UNITED STATES PATENT AND TRADEMARK OFFICE

10/581,784

Office Action Summary	Application No. 10/581,784	Applicant(s) KOZAKAI ET AL.	
	Examiner LINDA B. SMITH	Art Unit 2862

DETAILED ACTION

Fig. 3

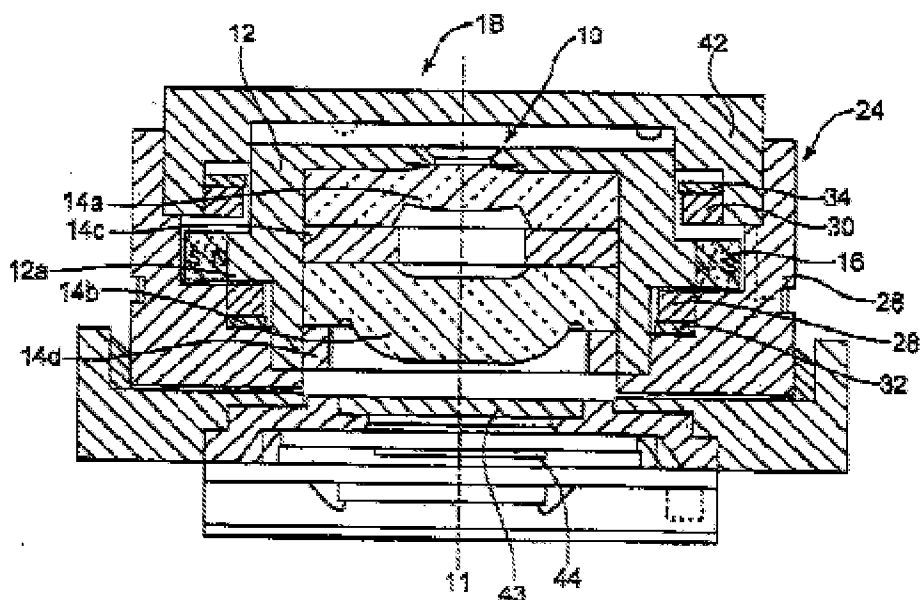
6. As to claim 1, Tsuruta discloses lens drive device comprising: a movable lens body (10) provided with a lens(14) (**abstract**), a drive means (16) for moving the movable lens body in an optical axis direction of the lens (**0021, 0049, and 0066**), and a fixing body (24) which movably supports the movable lens body in the optical axis direction (**0051 and 0066**), wherein the movable lens body is comprised of a lens-barrel provided with a lens and a lens-barrel holder which movably supports the lens-barrel in the optical axis direction (**0021, 0048, and Fig. 3 or Fig. 1**), the lens-barrel holder comprises a first magnetic means (16) as the drive means (**0071 and Fig. 3**), the fixing body (24) comprises a second magnetic means (**32 & 34**) as the drive means and a regulating part (**36 more clearly labeled in Fig. 8**) which regulates a moving range in the optical axis direction of the lens-barrel holder (**0057, lines 9-15, 0059 and 0061**), and the movable lens body is moved by a magnetic attractive force or a magnetic repulsive force between the first magnetic means and the second magnetic means (**0057 and 0075**).
